Drawing status			
PLANNING			
Client			
McCormick			
Project			
4 Golf Links Avenue + Bridewell			
Drawing title			
Proposed Site Layout Plan			
Drawn By	Checked By	Date	
CMY	KH	Nov 23	
Scale (@A1)		Project Number	
1:100		611	
Drawing Number			Rev
101			A

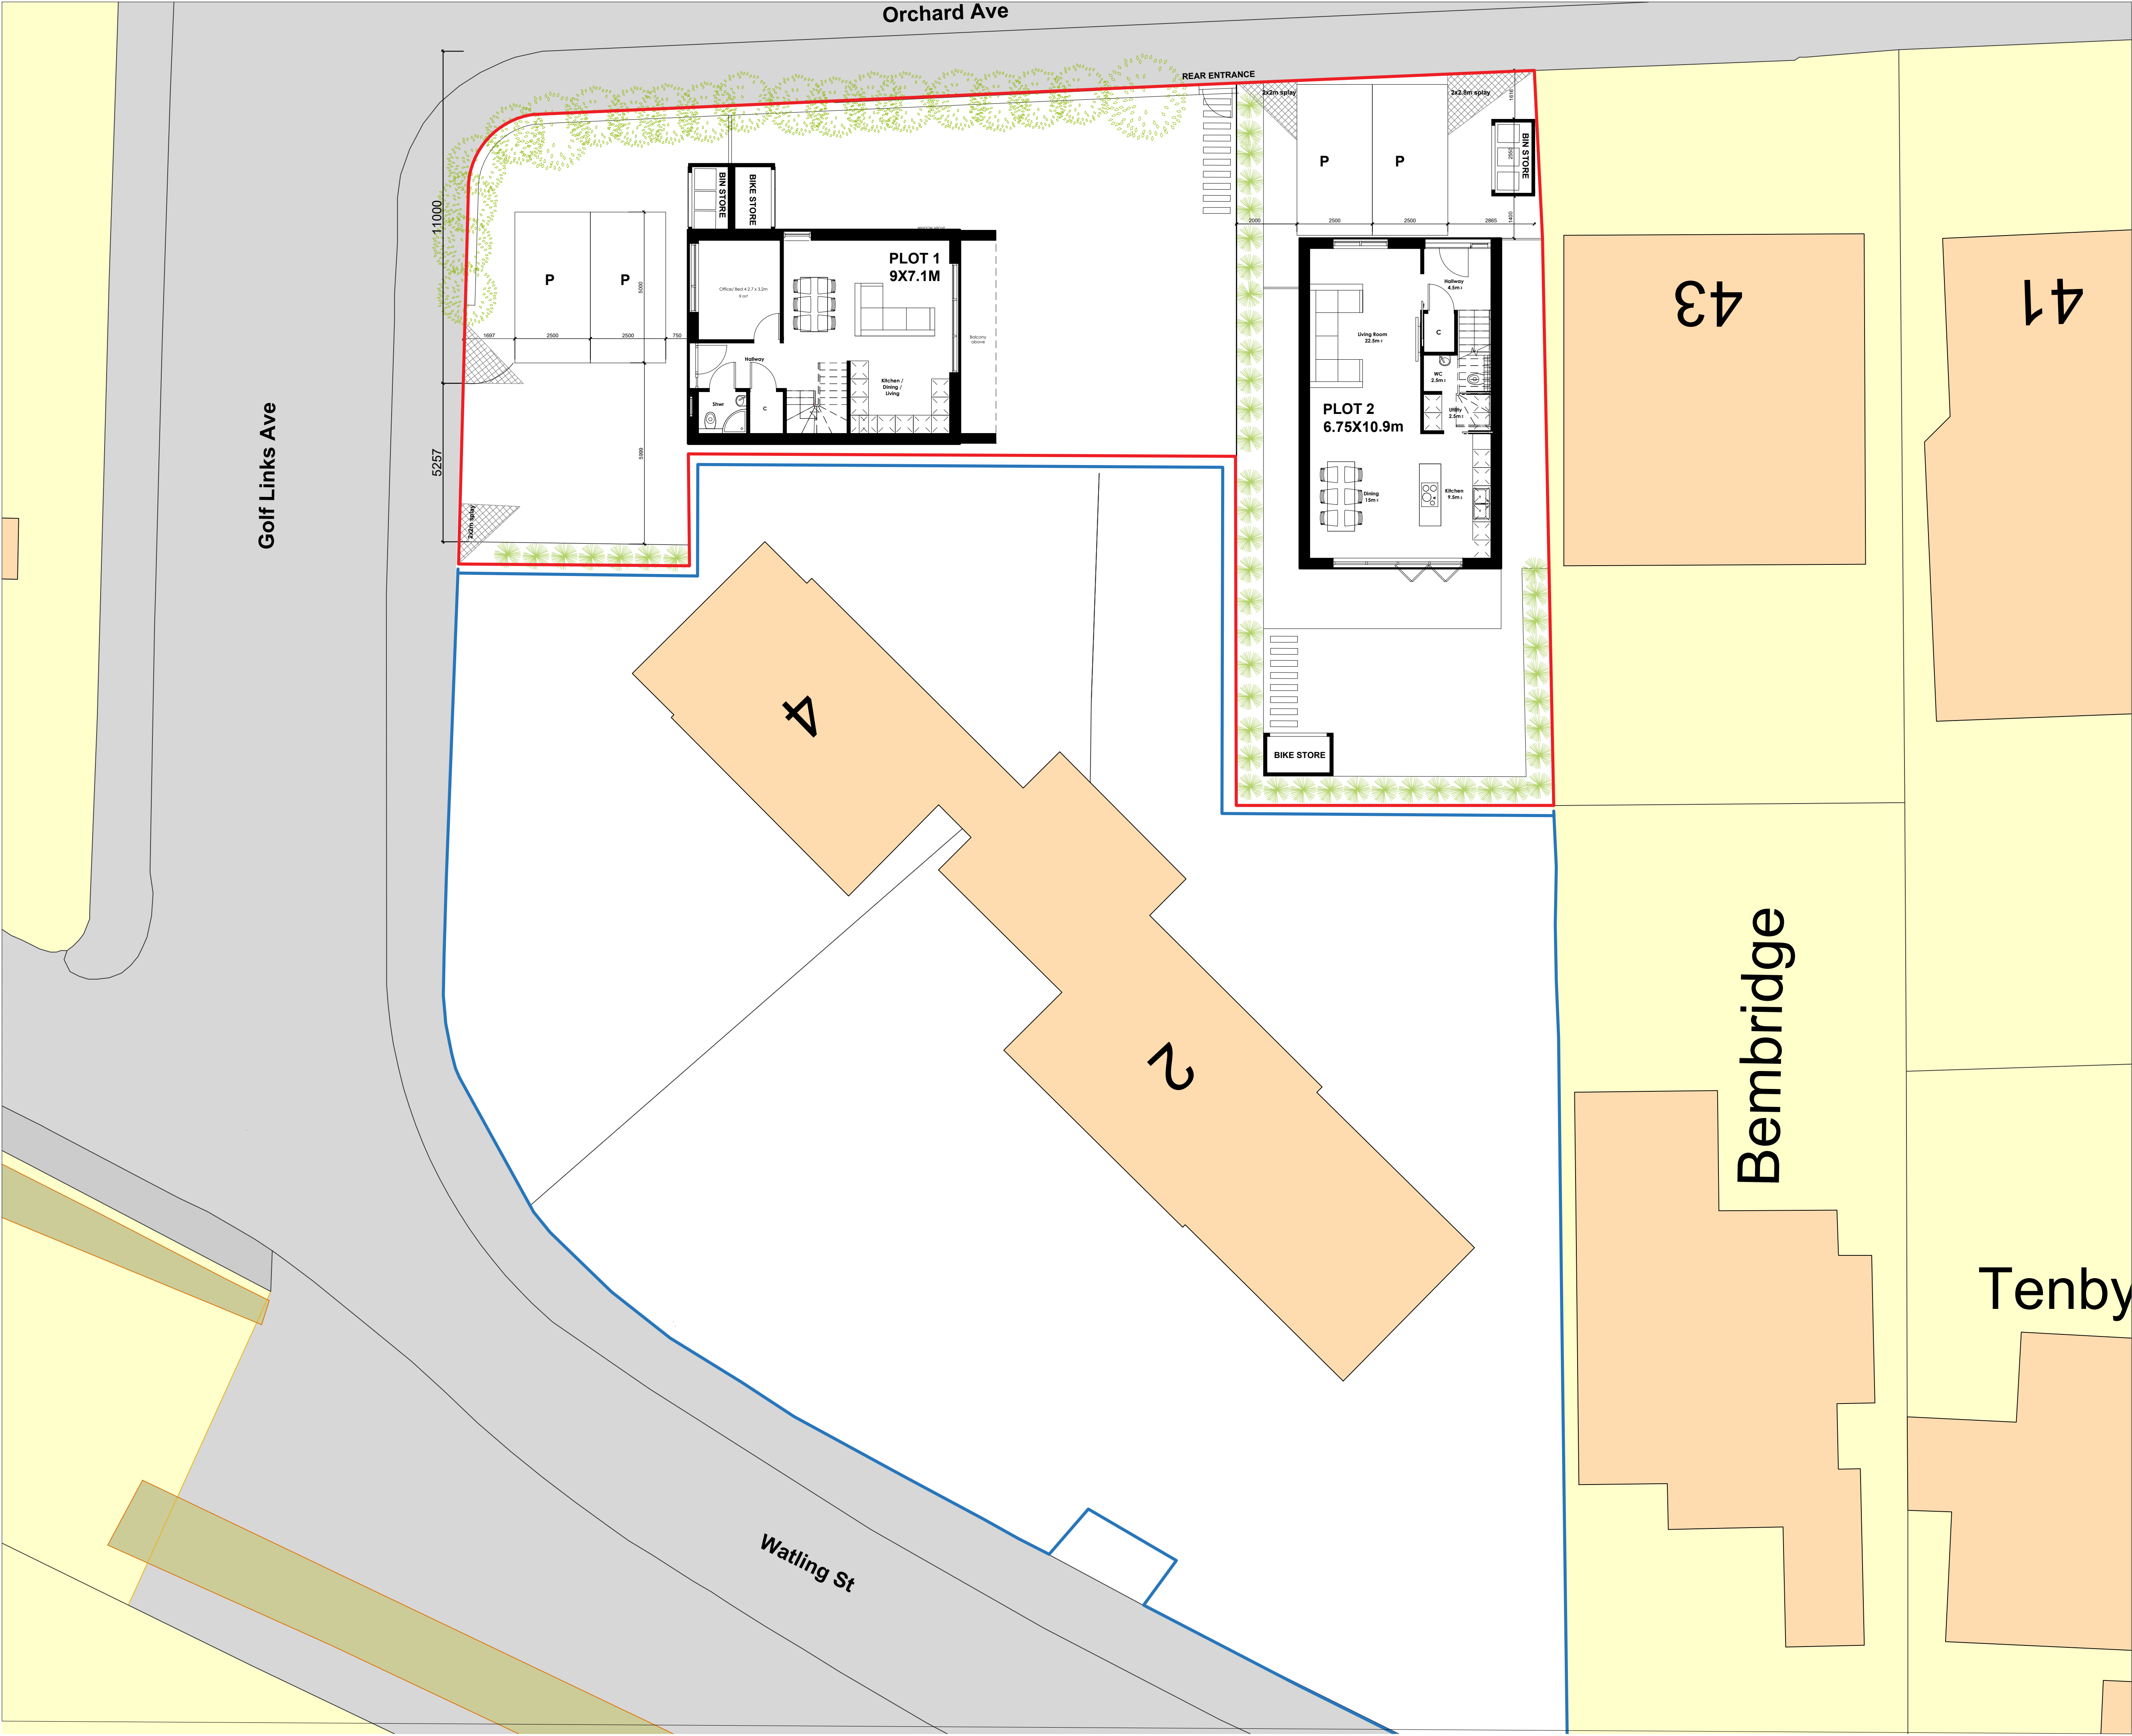
Revisions:			
Rev	CMY	16/11/23	Site Layout Plan updated to feature 2 houses, in response to comments from LPA: parking repositioned to ensure pedestrian visibility, parking for plot 2 placed 10m from junction. Semi detached houses reduced to one single detached house of different proportions. Blue/Red line updated to reflect changes.
A
